**CITY PLAN COMMISSION****THURSDAY, FEBRUARY 19, 2025****RECORD NO.:** PLAT-25-000183**SENIOR PLANNER:** Sharmila Shrestha**LOCATION:** Frankford Road, south of President George Bush Turnpike**DATE FILED:** January 21, 2026**ZONING:** A(A)**CITY COUNCIL DISTRICT:** 12**SIZE OF REQUEST:** 33.586-acres**APPLICANT/OWNER:** Oncor Electric Delivery Company, LLC

**REQUEST:** An application to replat a 33.586-acre tract of land containing all of Lot 1A in City Block A/8759 and a tract of land in City Block A/8759 to create one lot on property located on Frankford Road, south of President George Bush Turnpike.

**PRELIMINARY PLAT**  
**Frankford Road**  
**Sub Addition**  
**LOT 1B, BLOCK A8759**  
**NORTH SERVICE CENTER ADDITION**

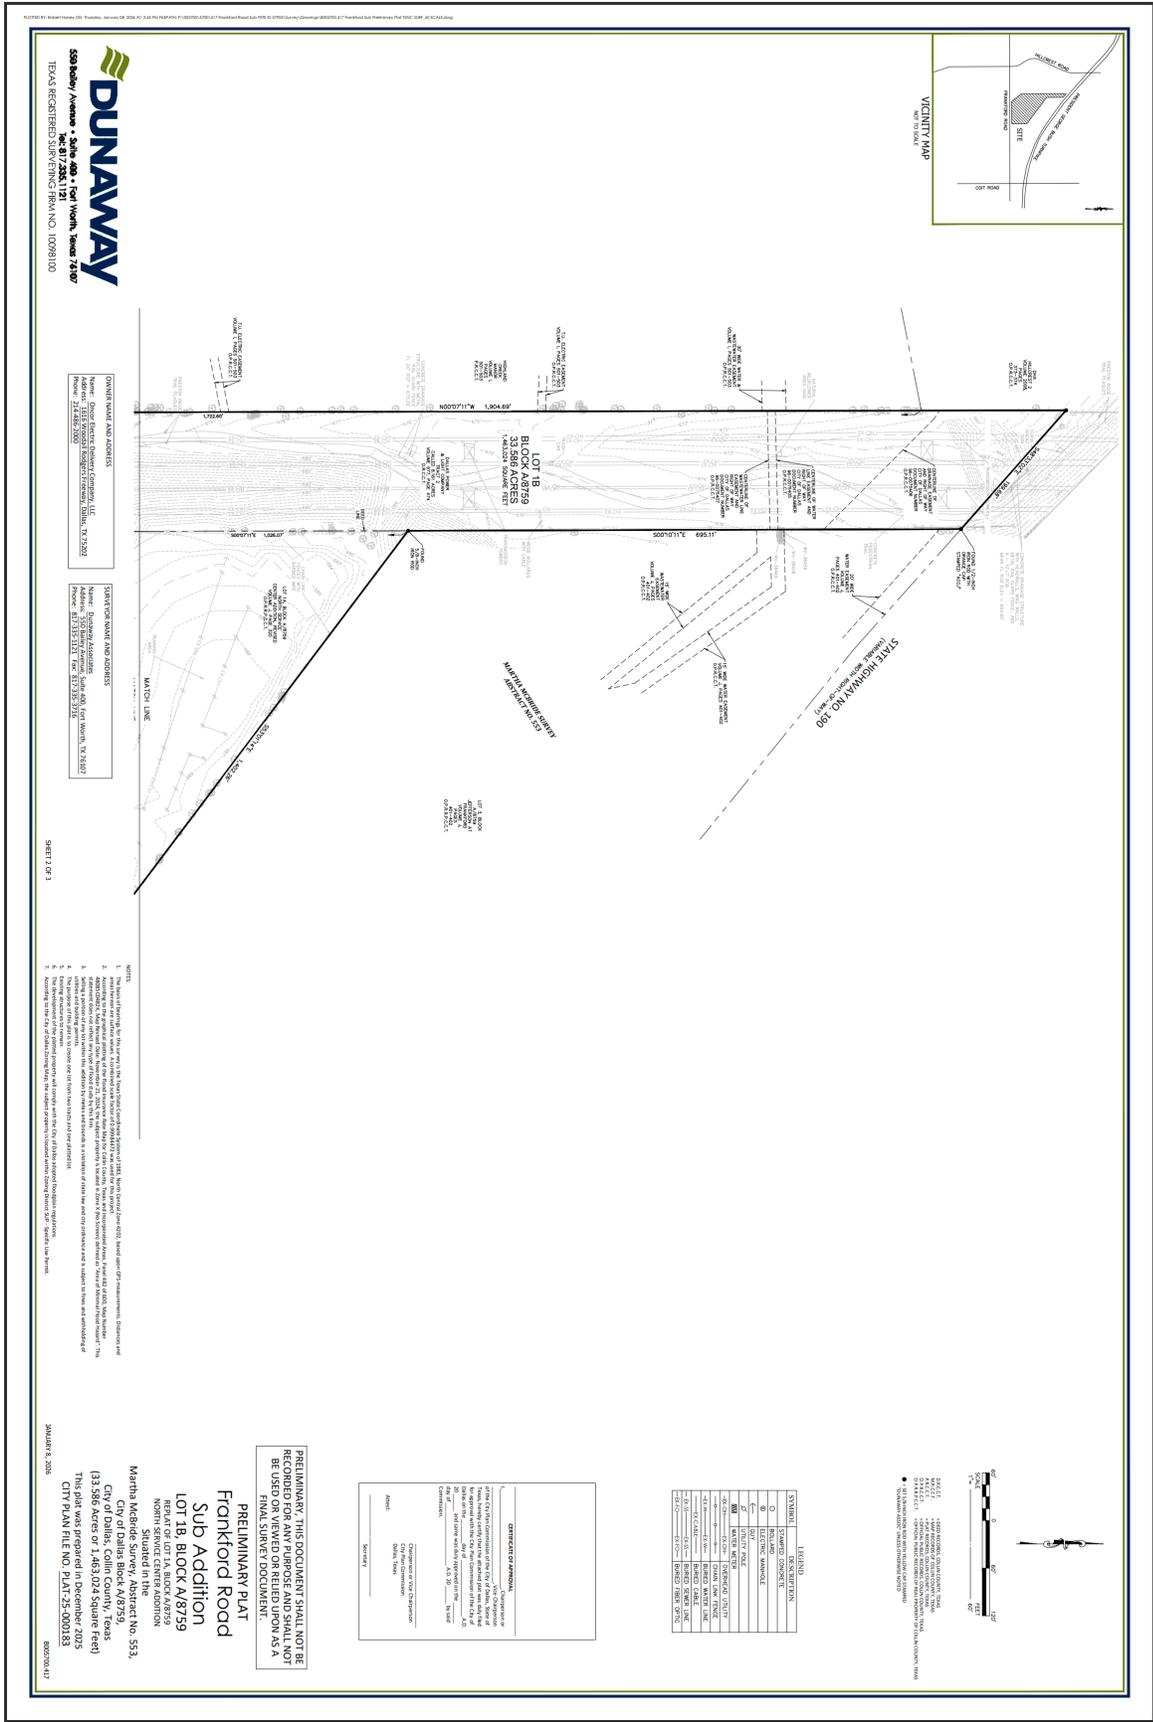
12. Submit a Full Set of Civil Engineering Plans (drainage, paving, street signage/marketing/lighting) prepared per City Standards by a licensed (TX) Professional Engineer to Engineering Division in Room 200, Oak Cliff Municipal Center (i.e., 311T/DP). Additions and alterations to the public infrastructure require approval and may require private development contracts with bonds.51A-8.102 (c); 8.601(b)(4), (5), (6), (7),(8),(9)
13. Detention may be required if the capacity of available outfall is not adequate to carry the developed runoff.51A 8.611(c)
14. Place a note on the final plat stating "Lot-to-Lot drainage will not be allowed without proper City of Dallas Engineering Division approval" 51A 8.611(e)
15. Existing drainage conveyance within the property is required to be sized in compliance with Section 51A-8.611(a)(1) of the City of Dallas Code.

16. Dedicate 50 feet of right-of-way (via fee simple) from the established center line of Frankford Road. Section 51A 8.602(c).
17. TXDOT approval may be required for any driveway modifications or new access.
18. Must coordinate with Transportation Department for any traffic signal requirements that are deemed necessary for improving pedestrian accessibility and safety related to site development (Contact Srinivasa Veeramallu with Traffic Signals). Section 51A-8.606, Section 51A-8.608

19. Submit a completed Final Plat Checklist and All Supporting Documentation.
20. Show correct recording information for subject property.
21. Show how all adjoining right-of-way was created.
22. Show distances/width across all adjoining right-of-way
23. Show recording information on all existing easements within 150 feet of property.

24. Show all additions or tracts of land within 150 feet of property with recording information.

25. Additional design information is required for assessment. Site plan must be submitted showing proposed development, building finished floor elevation, development, existing mains – including downstream manhole, and proposed water and wastewater service locations. Submit water/wastewater engineering plans to 320 E. Jefferson Blvd., Room 200, Attention: Water and Wastewater Engineering.
26. Water and wastewater main improvement may be required by Private Development Contract. Submit water/wastewater engineering plans to 320 E. Jefferson Blvd., Room 200, Attention: Water and Wastewater Engineering.
27. Existing and any proposed Water and Wastewater Easements must be shown and/or increased to conform to current design standards. Notice: Minimum DWU easement size is 20' for one utility and 25' for both water and sewer. Larger diameter or deeper mains may require additional width.

28. Additional design information needed to complete review. Provide a brief description of the proposed project and a copy of the site plan to [daniel.silva@dallas.gov](mailto:daniel.silva@dallas.gov) to determine street lighting requirements.
29. No tree removal until the required permits have been obtained
30. On the final plat, change “Frankford Rd” to “Frankford Road”.
31. On the final plat, change “State Highway No. 190” to “President George Bush Turnpike/ State Highway No. 190”.
32. On the final plat, identify the property as Lot 1B in City Block A/8759.
